Supplier Visit #2

CDCQ Press/Mould– Foshan

New 20ton (2U/2D) Press machine

Review –
Changes & Improvement point

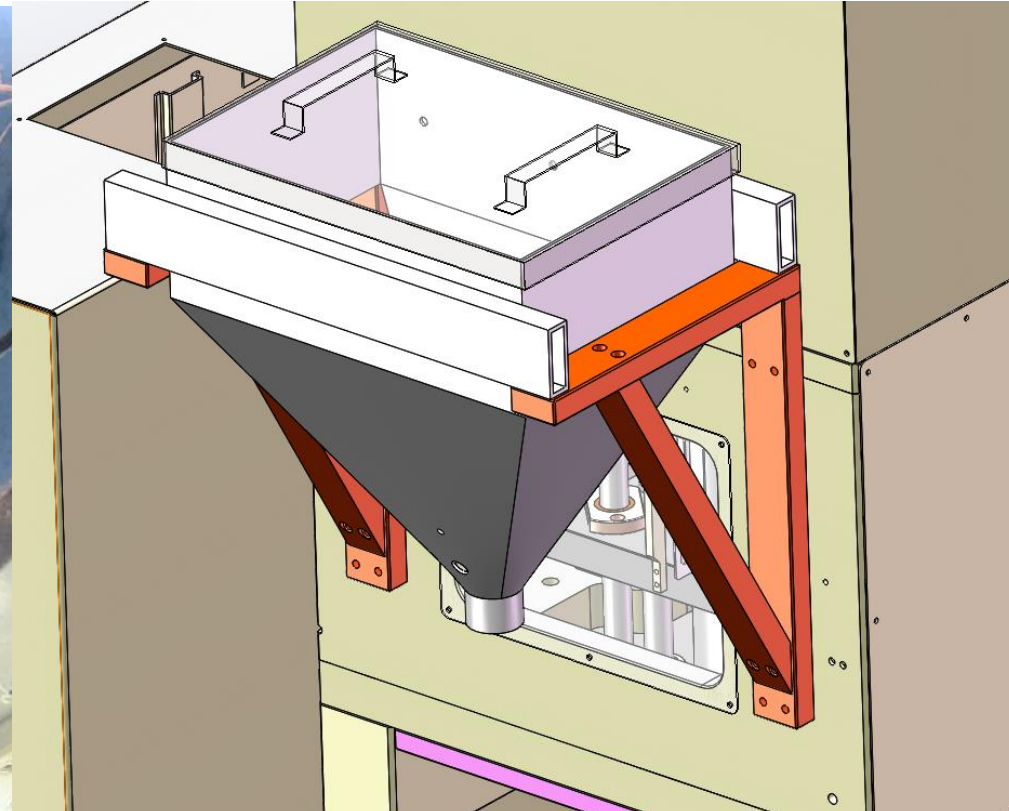
Increase the hopper capacity to 80KG
将料斗容量增加到80公斤

回复: **80KG**太大没有位置放
料斗容量变更为**40KG**

Re: 80KG is too big and there is no place to put it
Hopper capacity change to 40kg

TAMAGAWA

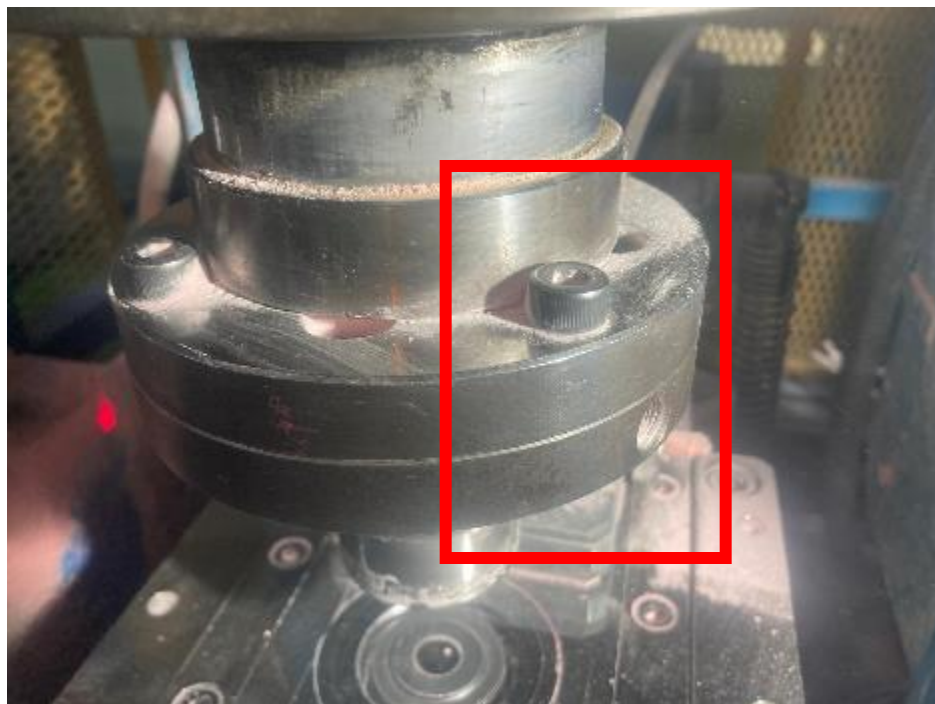
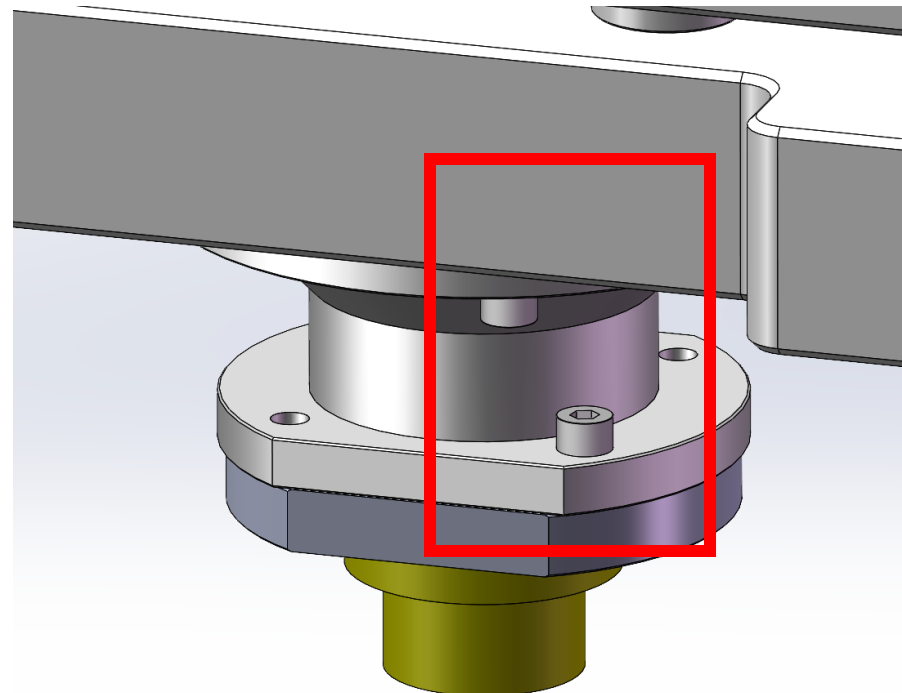
- The alignment shifts during pressing or after exceeding the maximum load by double pressing. The screws come loose (M6 -> M8).
- When setting up the upper punch, it is difficult to align the screw by turning it downwards.

Require similar like Tamagawa

Re: Will comply as per
Maruwa request

示意图

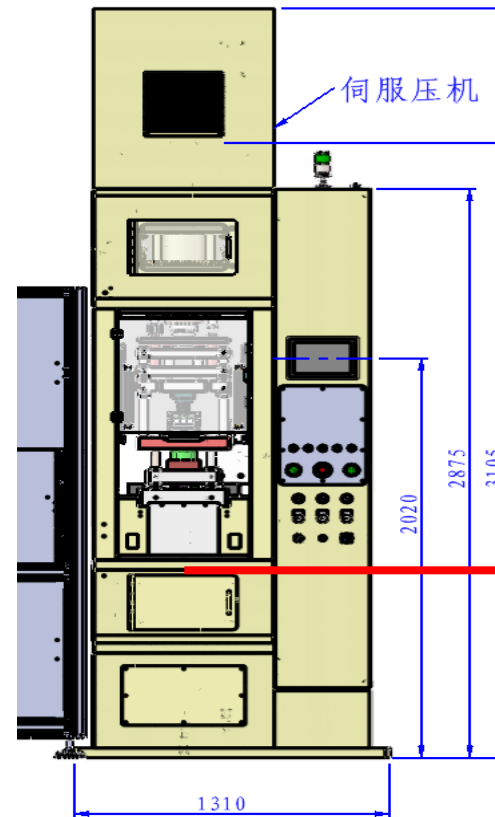
Max limit
 → No any gauge
 below this line

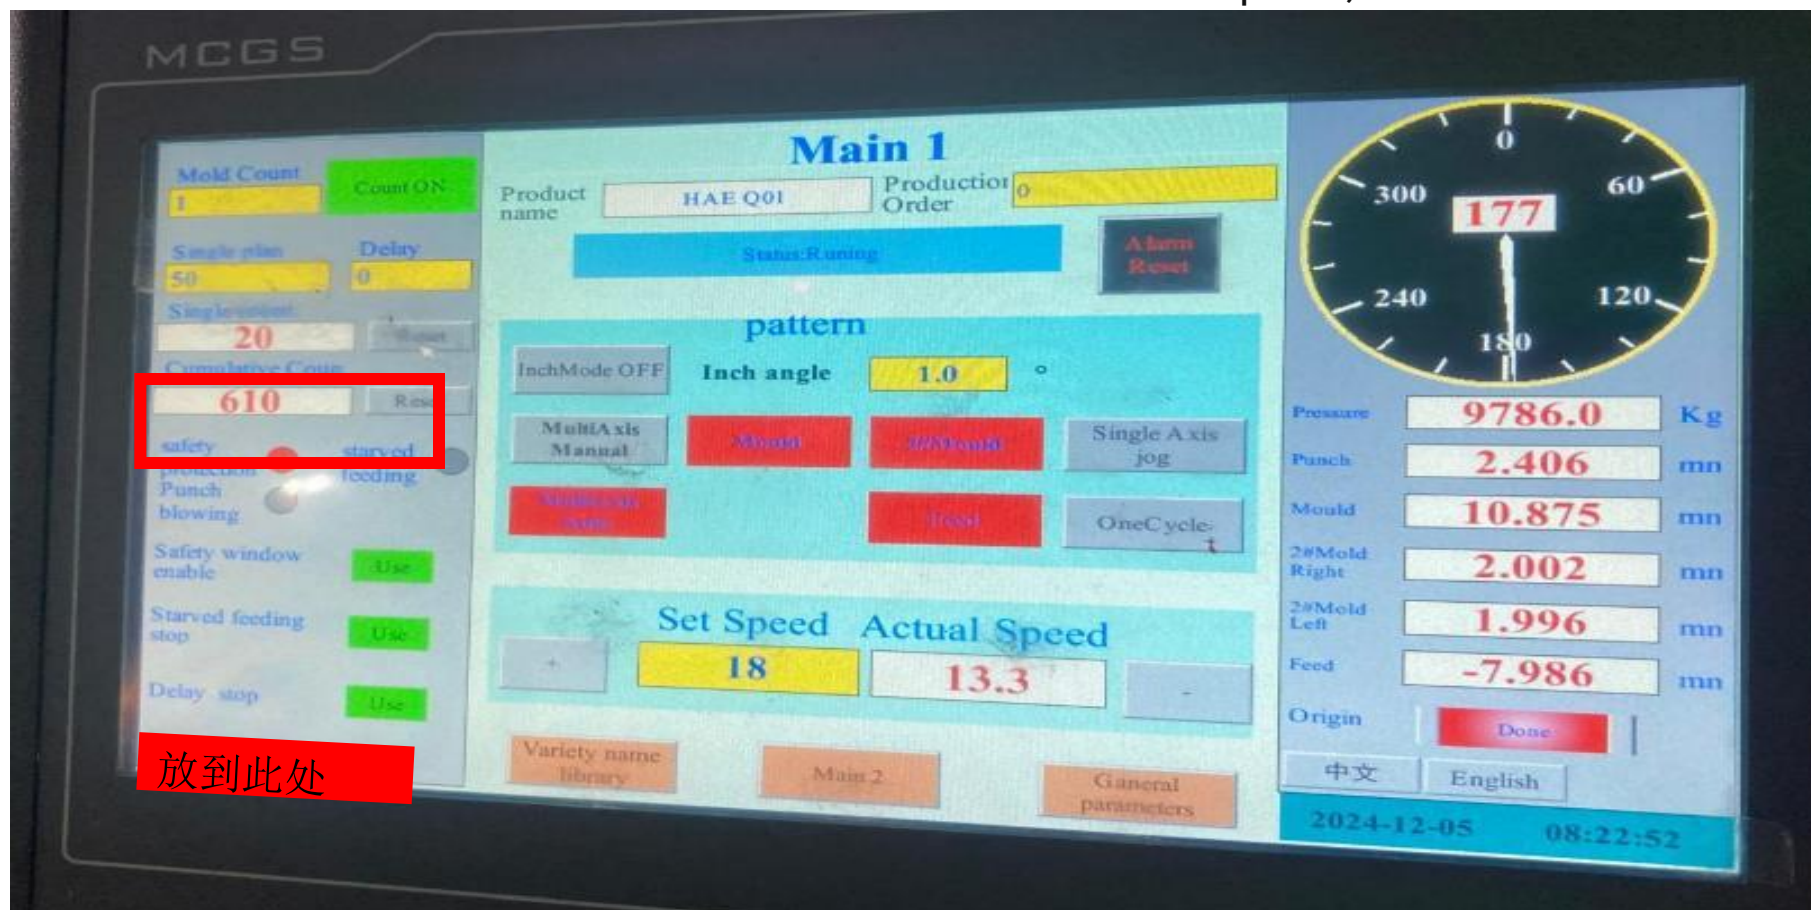
The operator mistook it for the mold cleaning counter and reset it.

→ A confirmation screen is required for mould cleaning

→ Relocate – mould cleaning button separately : operator always mistake

回复：位置更新，后续会出示意图

Re: Location update, intent will be shown later

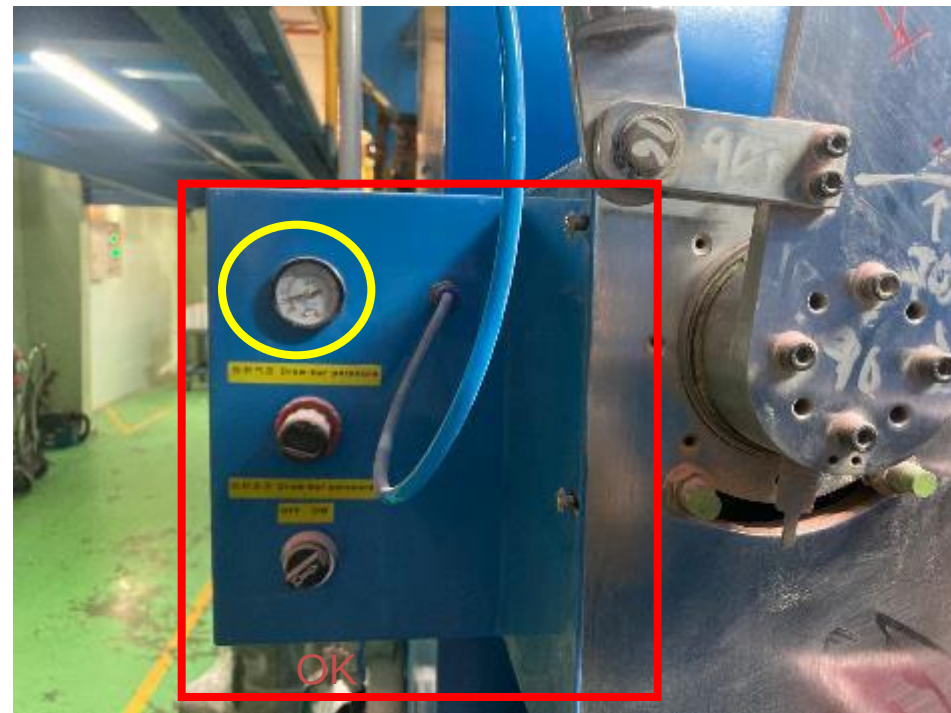
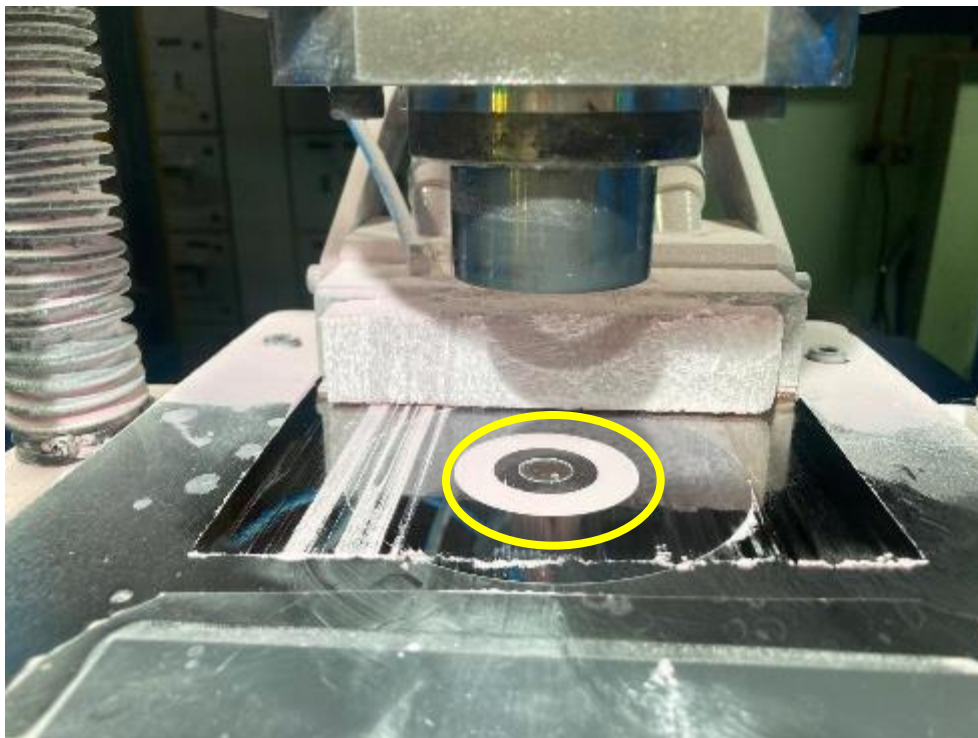
- powder filling unbalanced after increased machine speed
- Abnormal sound from feeder box when feeder go front (The time when pressure is high)

回复：跟粉料的流动性有关系，新机的粉盒要高\

Re: It has something to do with the fluidity of the powder, and the powder cartridge of the new machine should be high

售后跟踪，新机处理好才出机

After-sales tracking, the new machine is processed before it is released

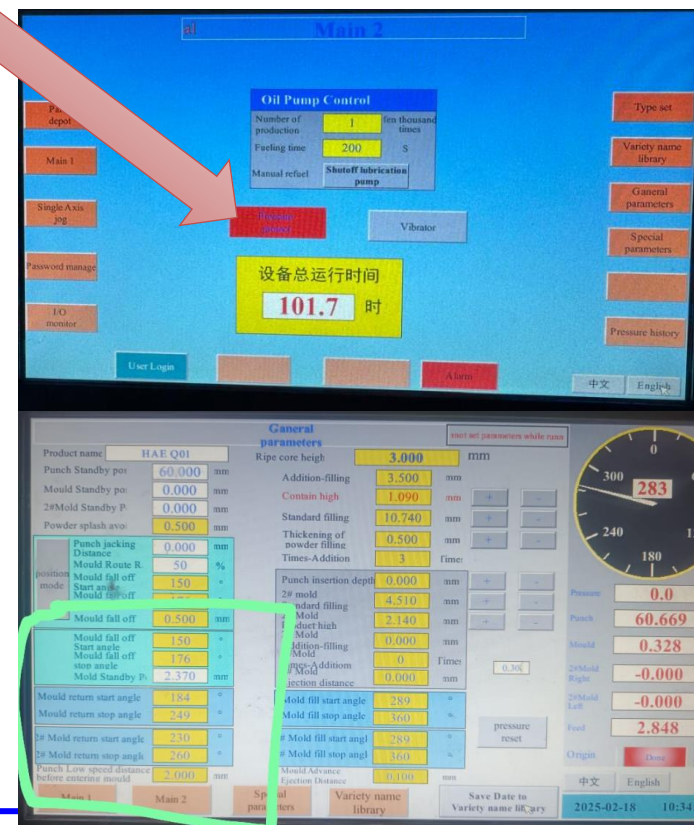
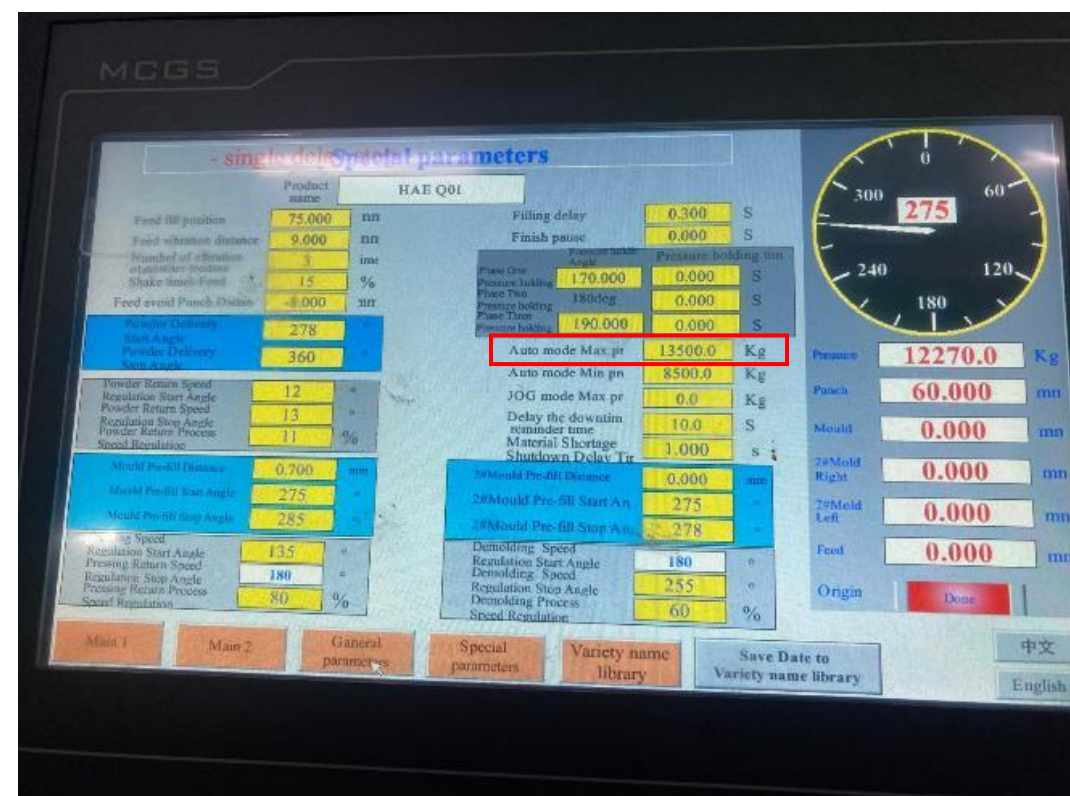
- It will be possible to control the pressure input.
- It will make an emergency stop the moment the pressure reaches this level or exceeds this level. The current function is slow to stop, and will only make an emergency stop once the pressure reaches 15 tons, 19 tons or more.

? **Need to add in auto stop when exceed setting spec**

Re: The pressure setting not activated → will update the software for to enable & disable

Similar software will be update for DP21

All parameter setting will be protected with password where the login will be recorded in the log

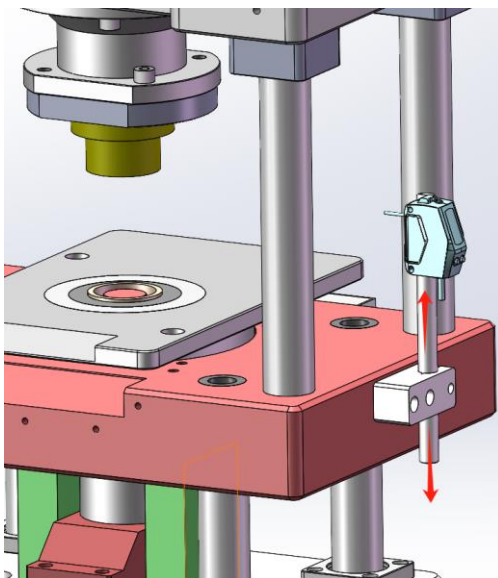
c.Double punch sensor 回复: 新设备有1个产品检测传感器
The new device has 1 product detection sensor (Location of the sensor & function timing) (OK)

Current Maruwa double punch sensor

回复: 激光位移传感器可上下移动, 也可以旋转

Re: The laser displacement sensor can be moved up and down as well as rotated
1.5ms/5ms/10ms switchable

Discuss internally to apply similar method

IoT – PLC Setting Parameter Info

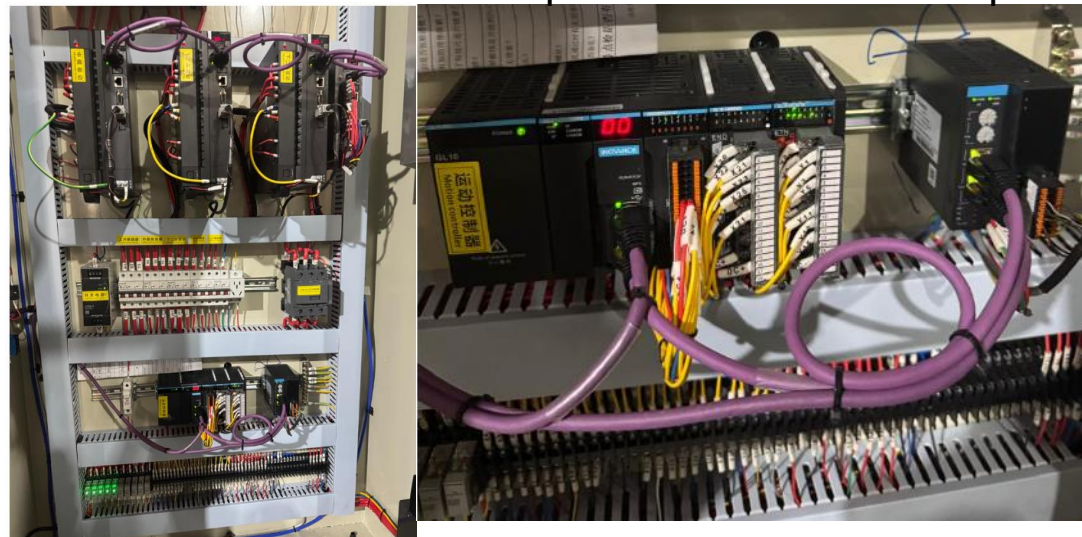
IP address : 192.168.3.123
Subnet : 255.255.255.0
Gateway: 192.168.3.254
Port No : **Not available**
Tag No : **Not Available**

* Requested to add on LAN port

CDCQ – Understood & provided

Address provided
➔ Test on 25/Feb

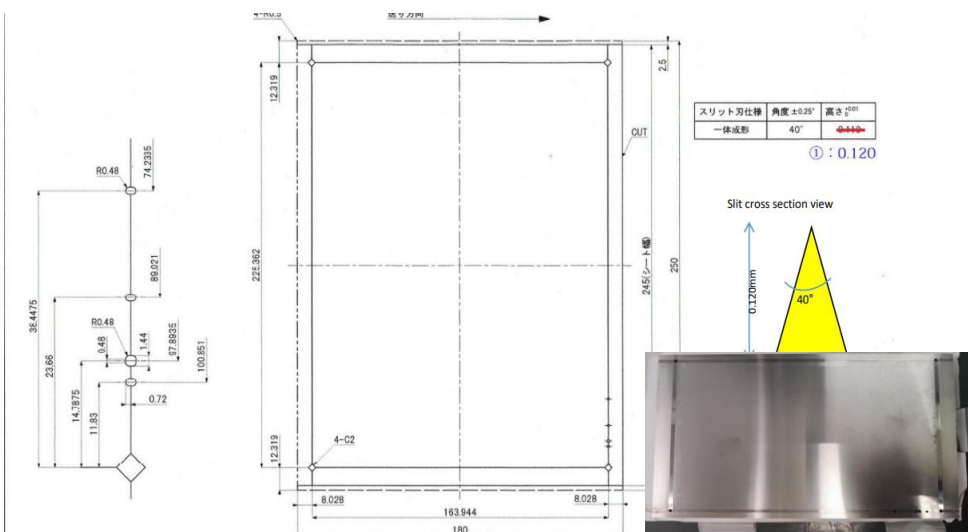
Maruwa – Required study by CDCQ
CV/HAE mould coating

→ HAE mould cleaning frequency :
150/cleaning

CDCQ : Will review the coating &
test at new 20ton Press machine
